Job No. 21-13556

Subject: **Addendum to the Report of Preliminary Geotechnical Investigation and Geologic Fault Investigation and Response to the City of San Diego Geotechnical Review**
Proposed Javaheri Residence
2072 Via Casa Alta
La Jolla, California

City of San Diego Development Services Department, 2023, LDR-Geology Cycle Issues, Project No. 698915 – L64A-0003B.

Project		SECTION A-A'	
	Analysis Description		BLOCK SLOPE STABILITY	
	Drawn By	R.A.C.	Scale	1:1775
Date		5/25/2023 10:14:44 AM	Company	G.E.I.
Slide Interpret 6.039		File Name	JOB NO. 21-13556_S(A)_03w_0.15gSHAKE.slim

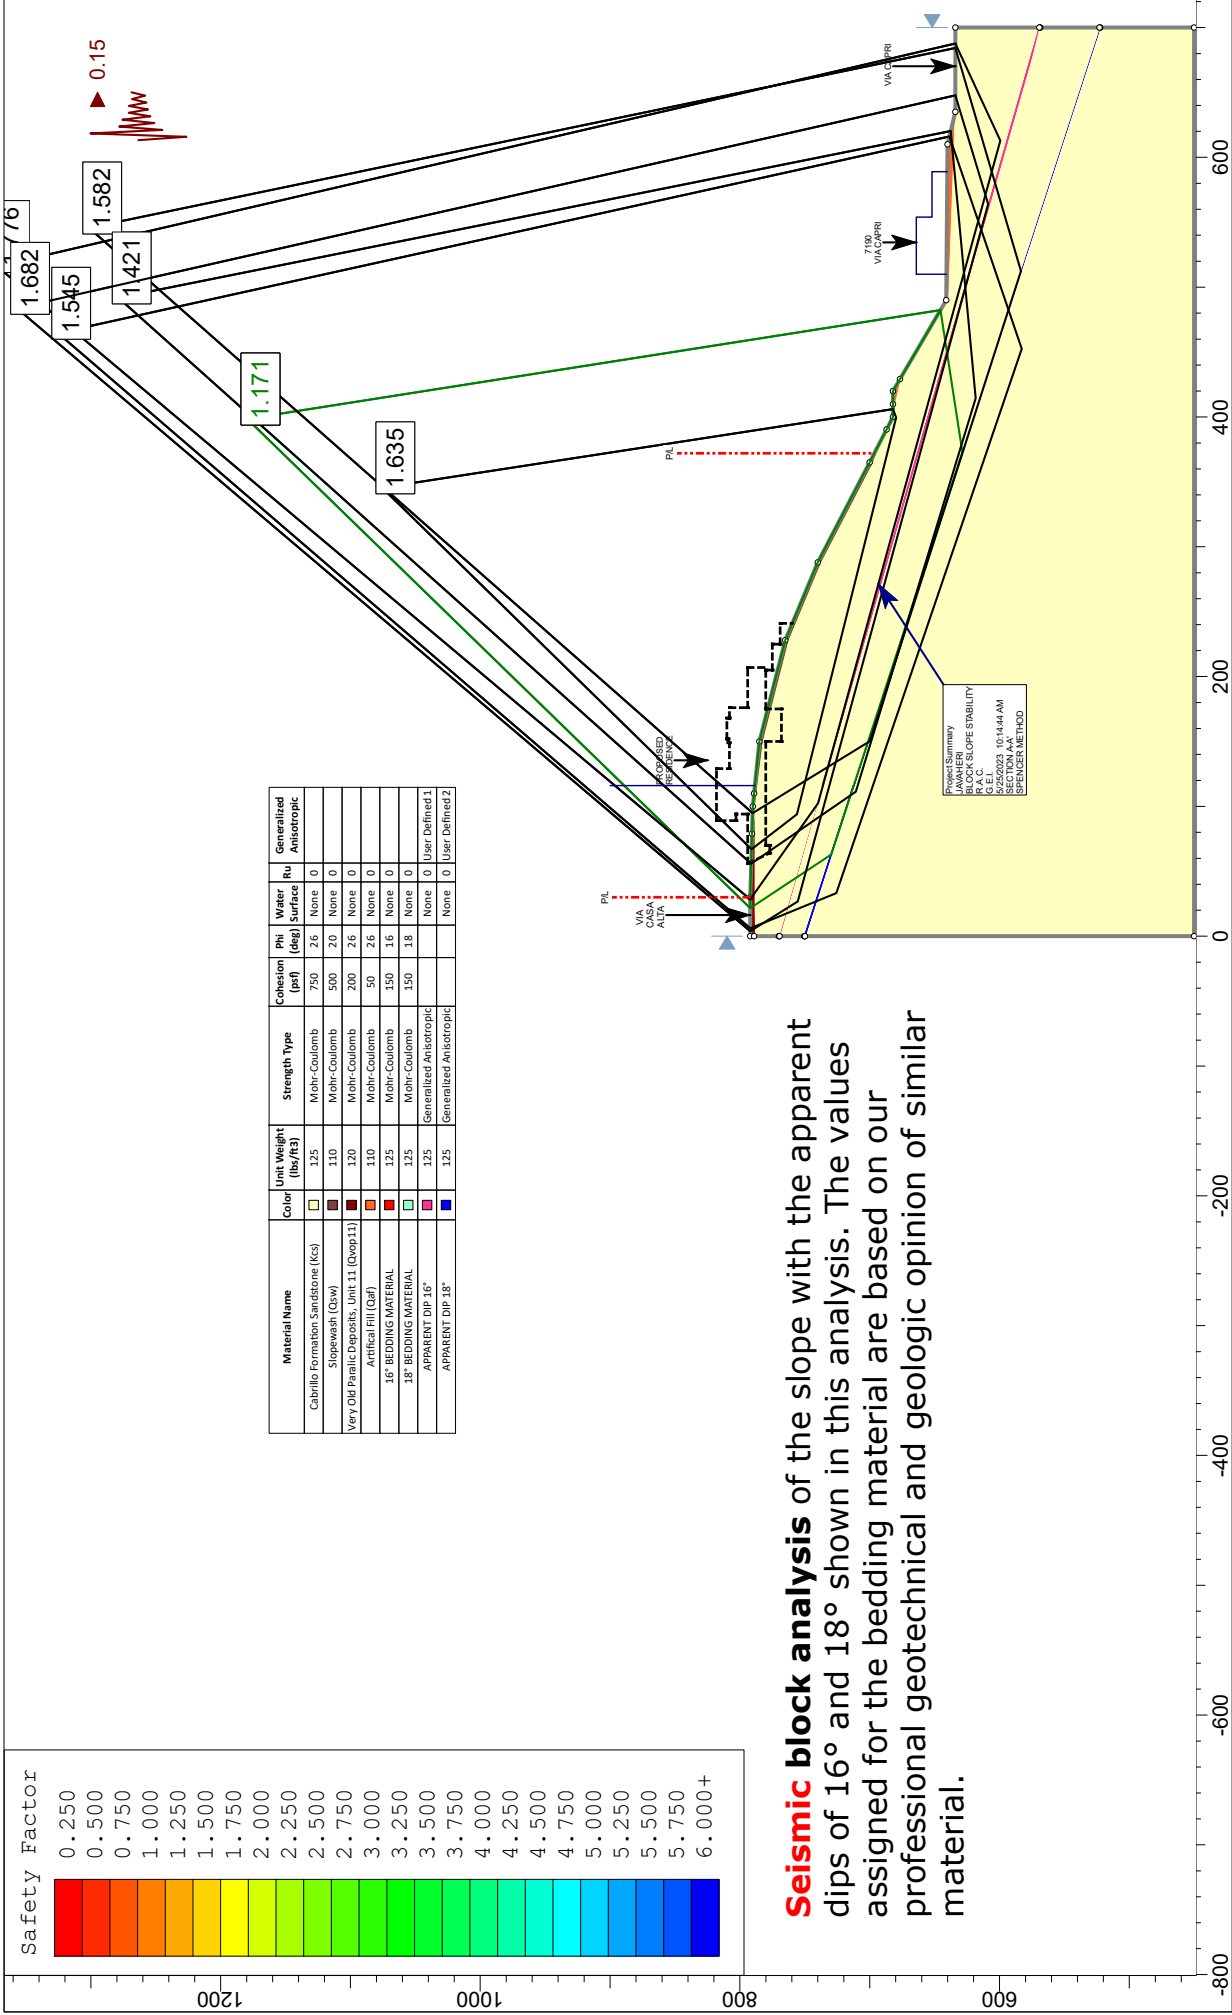
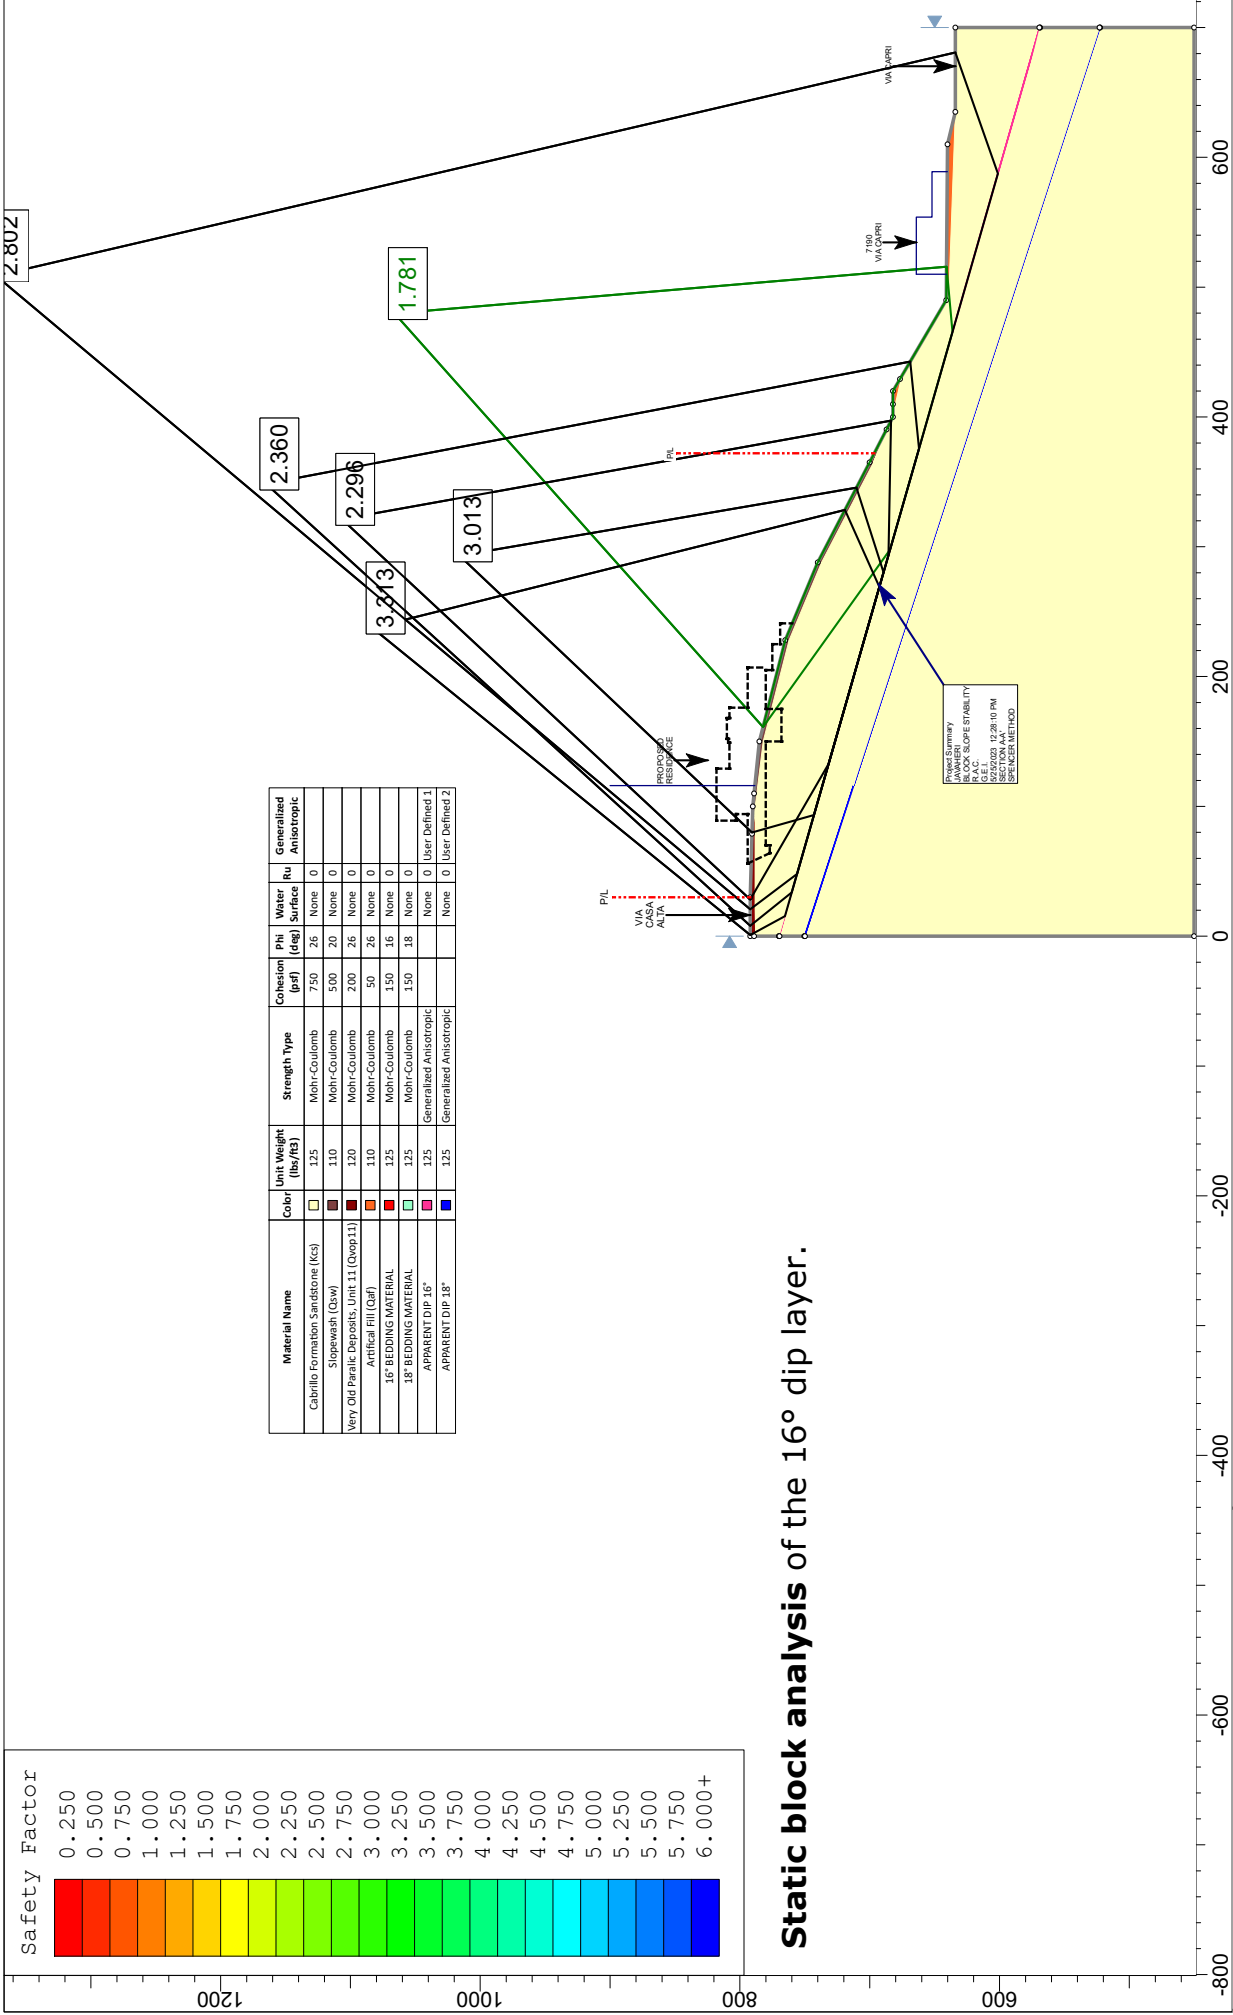
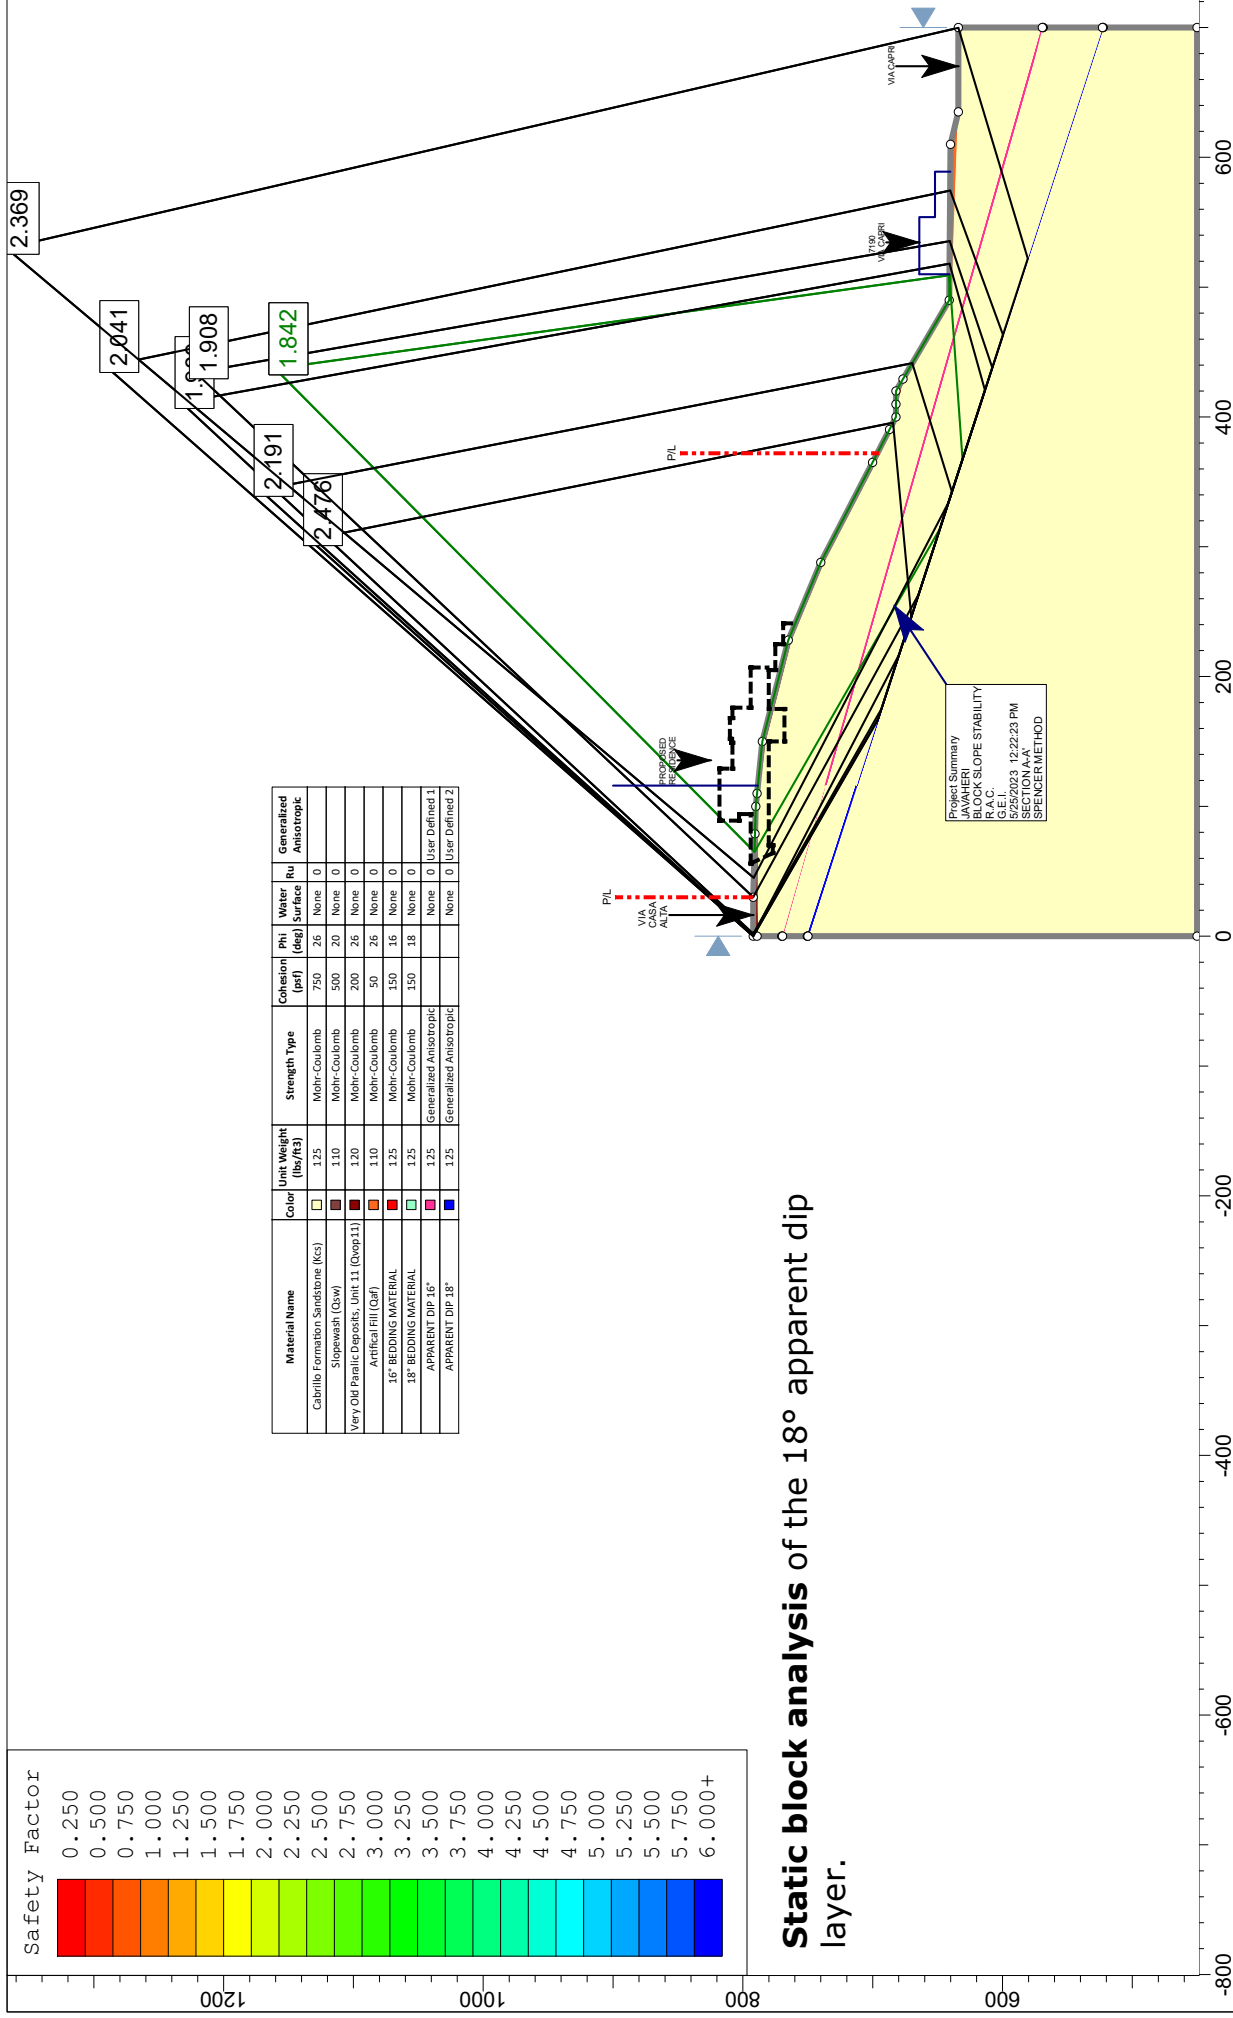
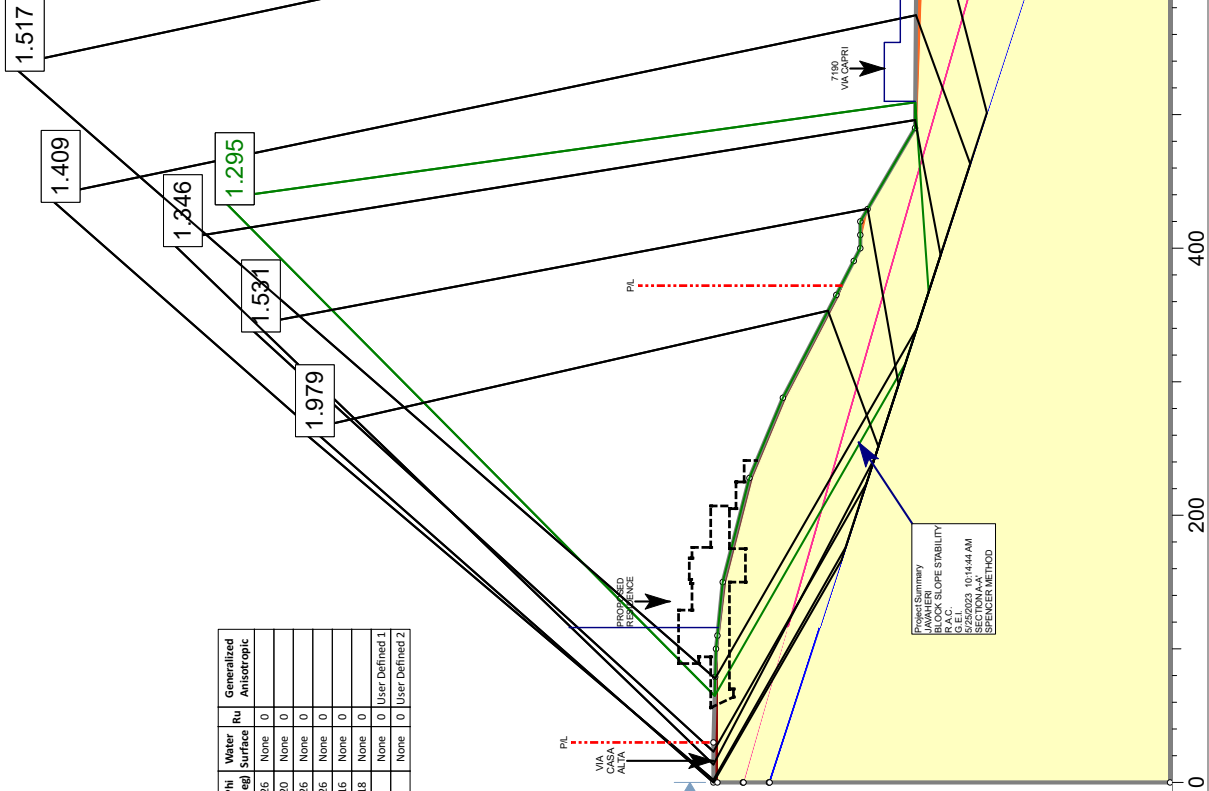
Issue No. 9: *Demonstrate the site will have a factor of safety of 1.5 or greater with respect to gross and surficial slope stability following completion of the project. Provide slope stability analyses consistent with the geologic cross sections. (From Cycle 2)*

Issue No. 24: *The project's geotechnical consultant should clarify if their stability analysis presented in the submitted report included site-specific bedding and geologic structure data. As per the City's Guidelines for Geotechnical Reports, describe the stability analysis and discuss the results. The description should include the method of analysis, specified material profile, and specified search areas for critical failure paths. Where multiple slope stability analyses are conducted, a tabulated summary of the analyses and results should be provided. (New Issue)*

Response: We are providing a slope stability analysis based on cross section A-A' through the site. Based on our revised gross and surficial slope stability analysis, the site has a factor of safety of 1.5 or greater and a factor of safety of at least 1.15 in seismic loading analysis. Refer to attached Figure Nos. I and II for the geologic cross section through the site and Appendix A for slope stability analysis.

Response: The slope stability analysis, presented here as Appendix A, includes site-specific bedding and geologic structure data as well as the method of analysis, specified material profile, and specified search areas for critical failure paths. A tabulated summary of the analyses and results is also provided in Appendix A.
